**SOLICITATION AMENDMENT
MODIFICATION DE L'INVITATION**

AMENDEMENT 006

Title: RELOCATION OF THE CHAPAIS FARM

ADD-ENG02

**ASPHALT PROPOSED STRUCTURES
ASPHALTE STRUCTURES PROPOSÉES**

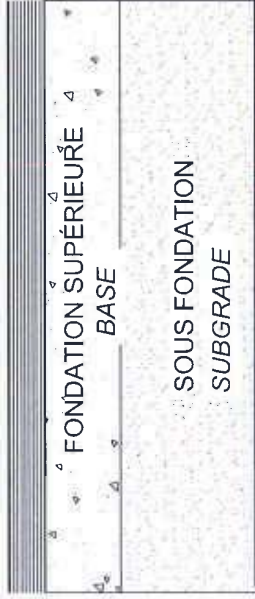
.2 Drawing C06/09 - Details

- .1 Add pavement structure to route 138 (contractor must allow for necessary corrective measures to route 138 following his own excavations). Allow for application of MTQ standards for transition of infrastructure and pavement. See attached sketch.
- .2 Grass is cultivated grass as described on architectural drawings. Always refer to architectural drawings for sodding as indicated on civil drawings.
- .3 Allow pavement structure with gravel or pavement around manholes and catch basins.

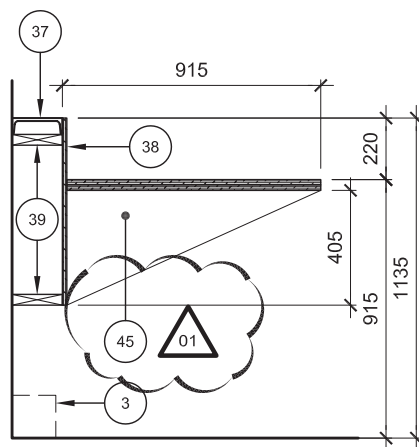
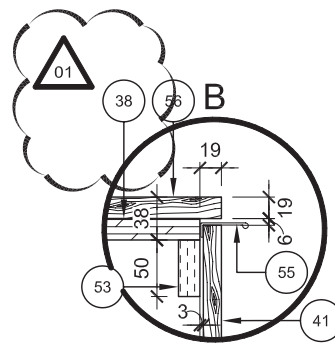
- 2.1.3 Note 59 from *Integrated Furniture Specific Notes* is eliminated. Refer to drawing extract #02 in attachment.
- 2.2 Page A-1104
 - 2.2.1 Section B is modified as follows: replace note (45) by (38). Refer to drawing extract #01 in attachment.

- 2.2.2 Section C11 is modified as follows: replace note 2x (45) by (45). Refer to drawing extract #01 in attachment.
 - 2.2.3 Section C14 is modified as follows: replace note 2x (45) by (45). Refer to drawing extract #01 in attachment.

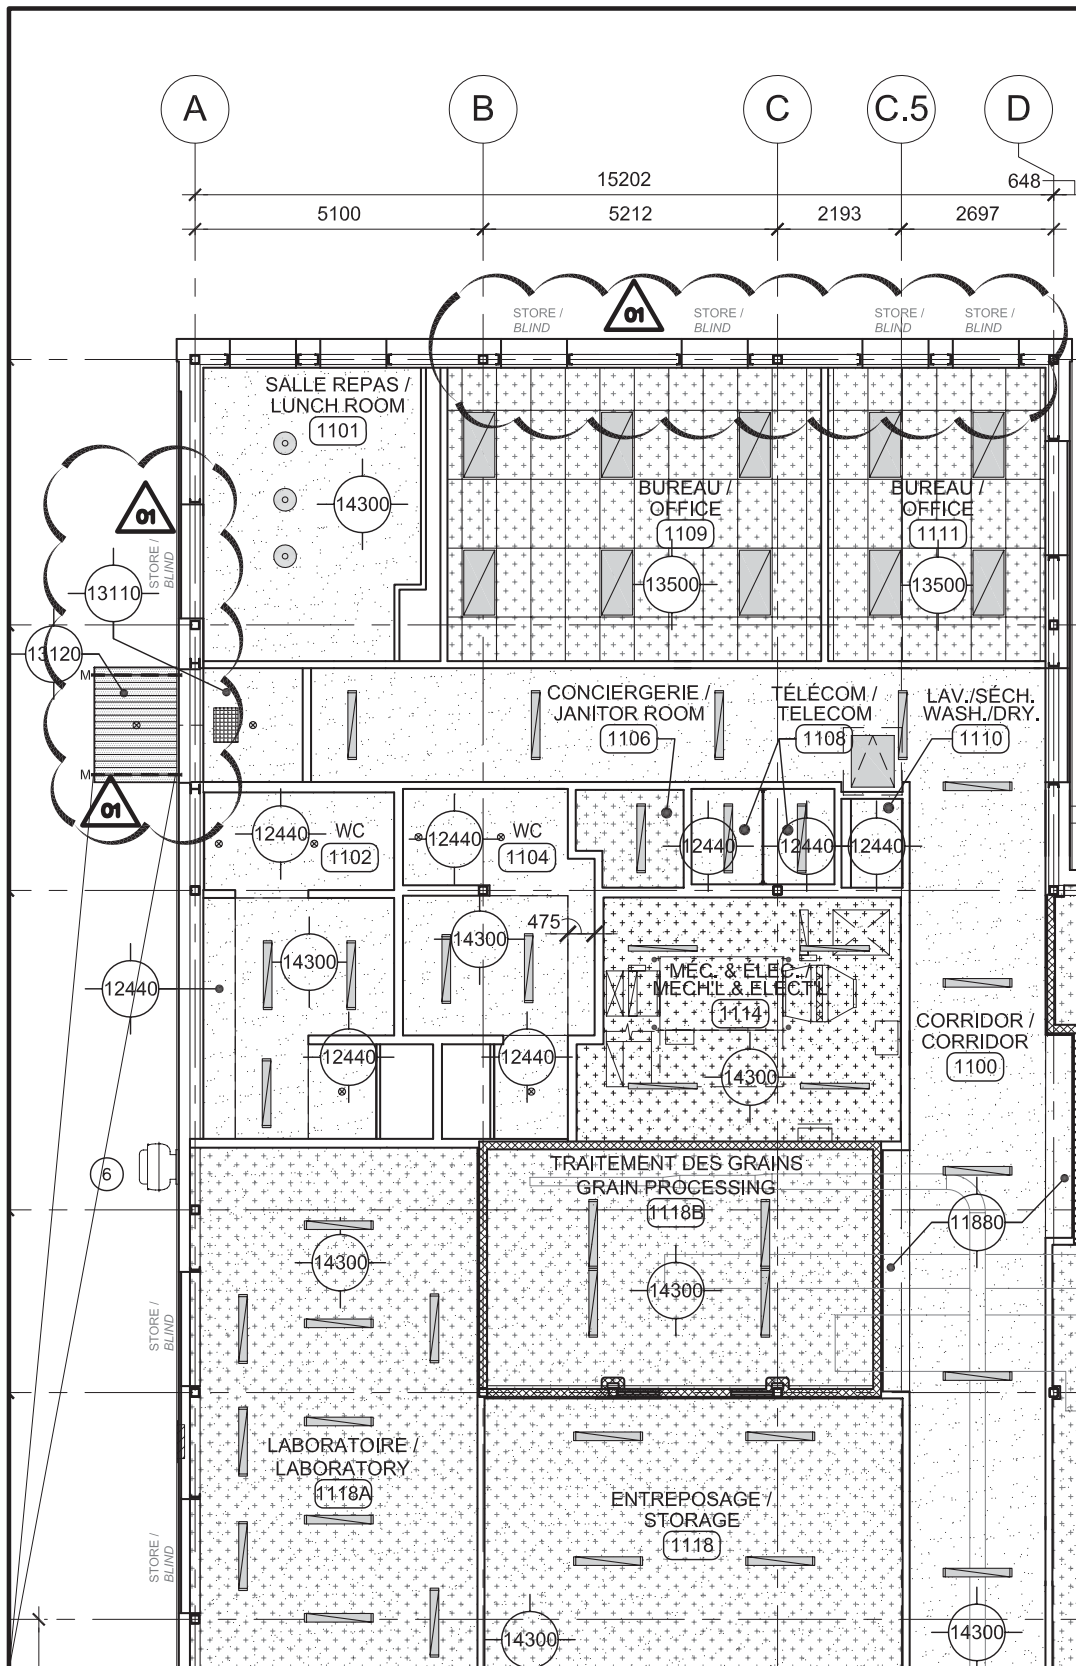
- 2.1 A-1100 series
 - 2.1.1 All exposed fasteners (note 59) are eliminated. The fasteners will be concealed.
 - 2.1.2 Note 45 from *Integrated Furniture Specific Notes* is modified as follows: **2x 19mm plywood covered with laminated plastic on all visible sides**. Refer to drawing extract #02 in attachment.

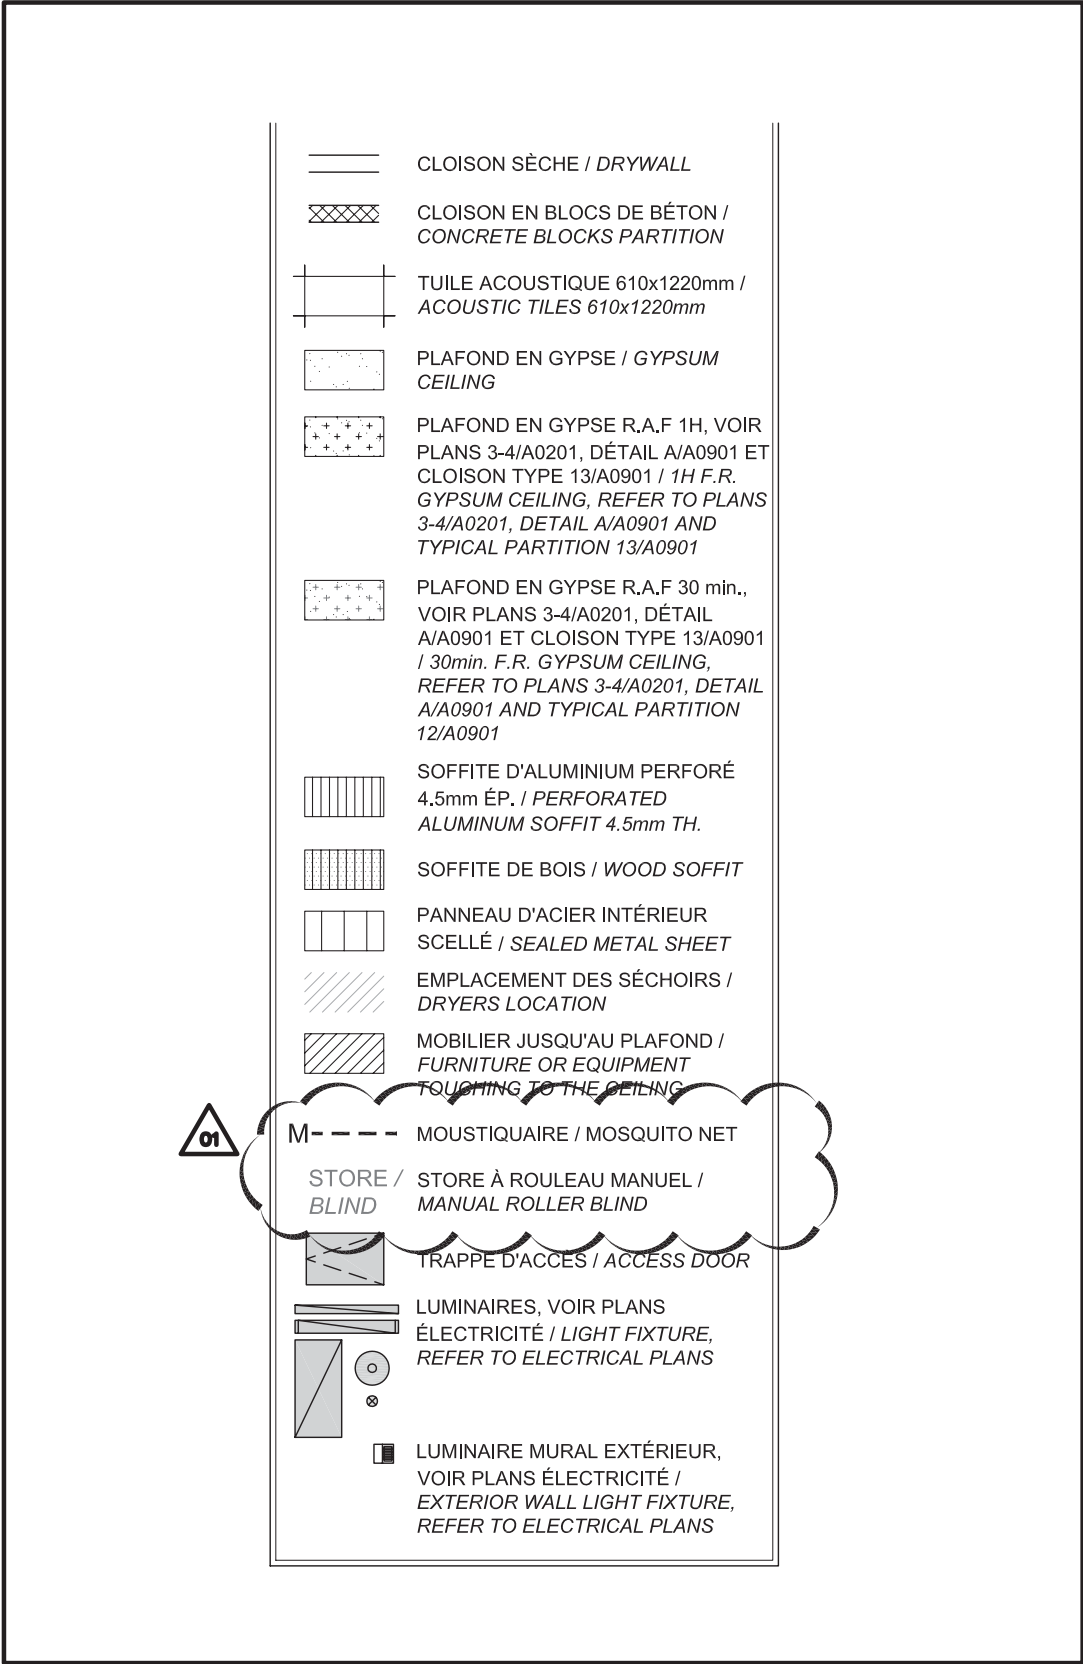
- 2.3 Page A-1201
 - 2.3.1 Modification of mosquito screen graphic reference in *FSA-01 Reflected Ceiling Plan*. Refer to drawing extract #03 in attachment.

- 2.3.2 Location of manual roller blinds in *FSA-01 Reflected Ceiling Plan*. Refer to drawing extract #03 in attachment.
 - 2.3.3 In *Ceiling Drawing Legend*, screen and roller blind graphic references are modified. Refer to drawing extract #04 in attachment.

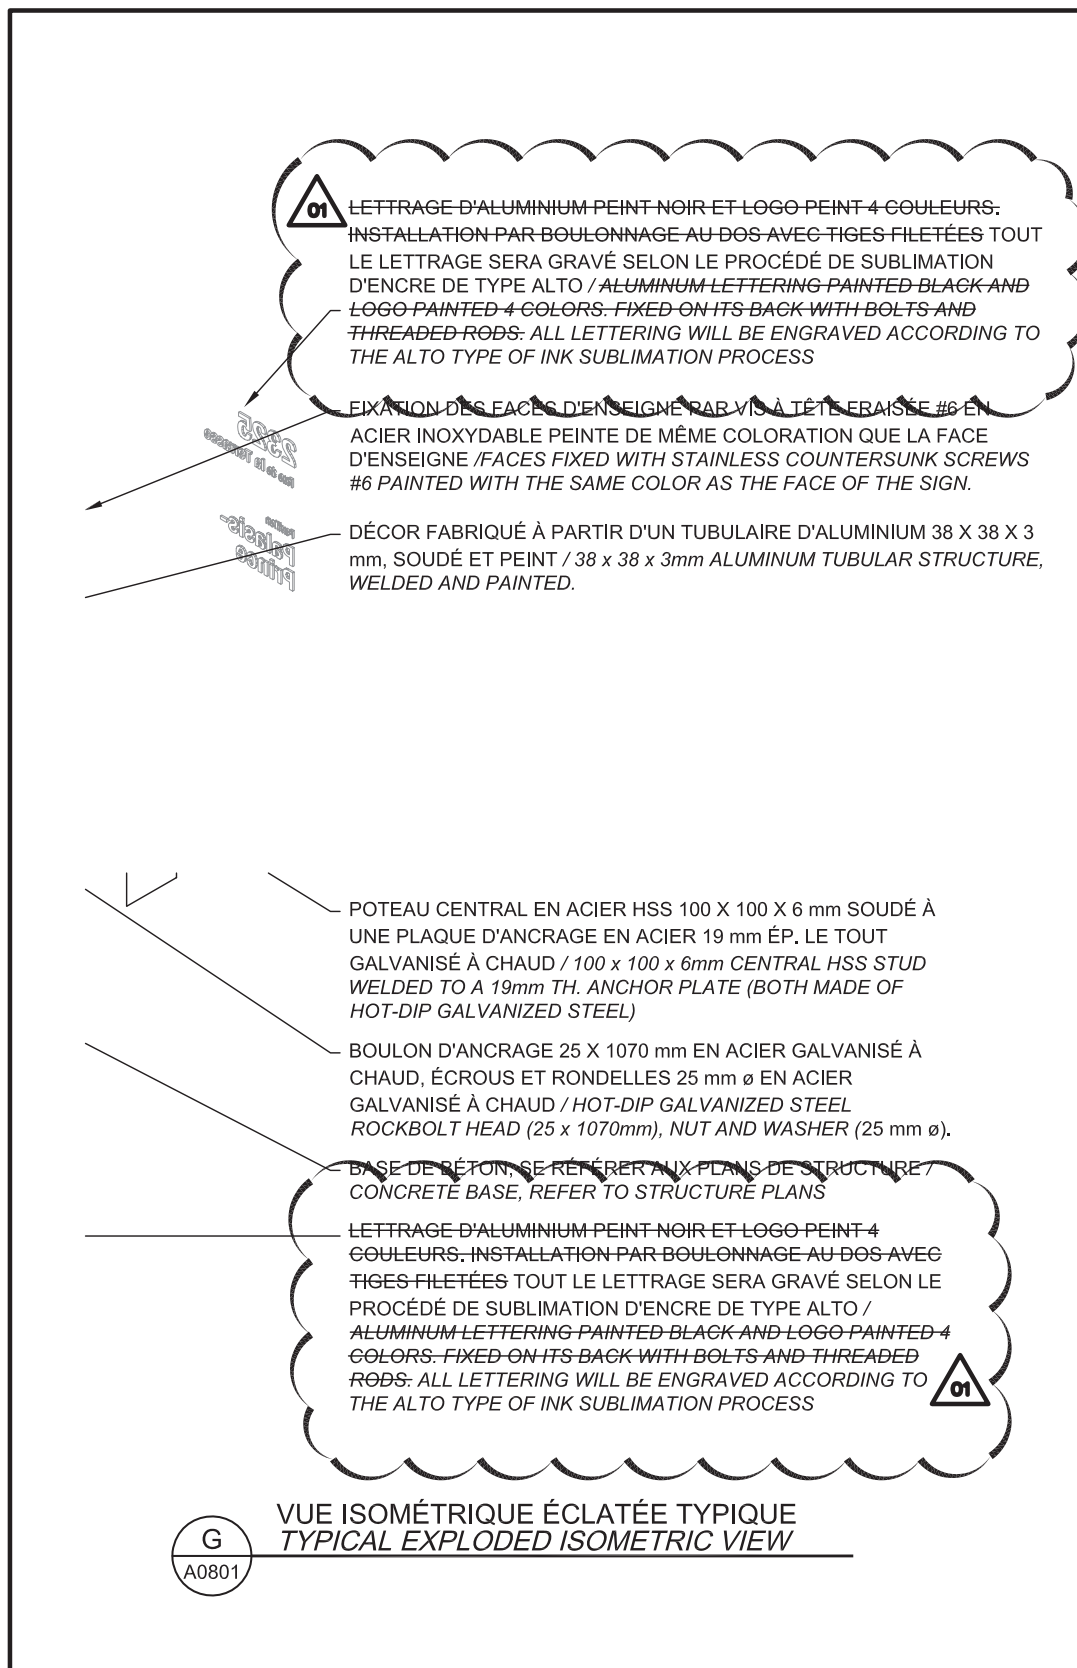
- 2.6.1 In drawings B and C, a new display area is created to include the centre RISC. An upcoming design featuring the following information will be provided for the sign:
" Multisite d'entraînement et de simulation pratique en sécurité civile
Centre RISC – Centre de recherche et d'innovation en sécurité civile
Campus Notre-Dame-de-Foy "
Refer to drawing extract #05 in attachment.
- 2.6.2 In drawing G, *Typical Exploded Isometric View*, the description of the lettering should be read instead as follows: **All lettering will be engraved according to the alto type of ink sublimation process.** Refer to drawing extract #06 in attachment.
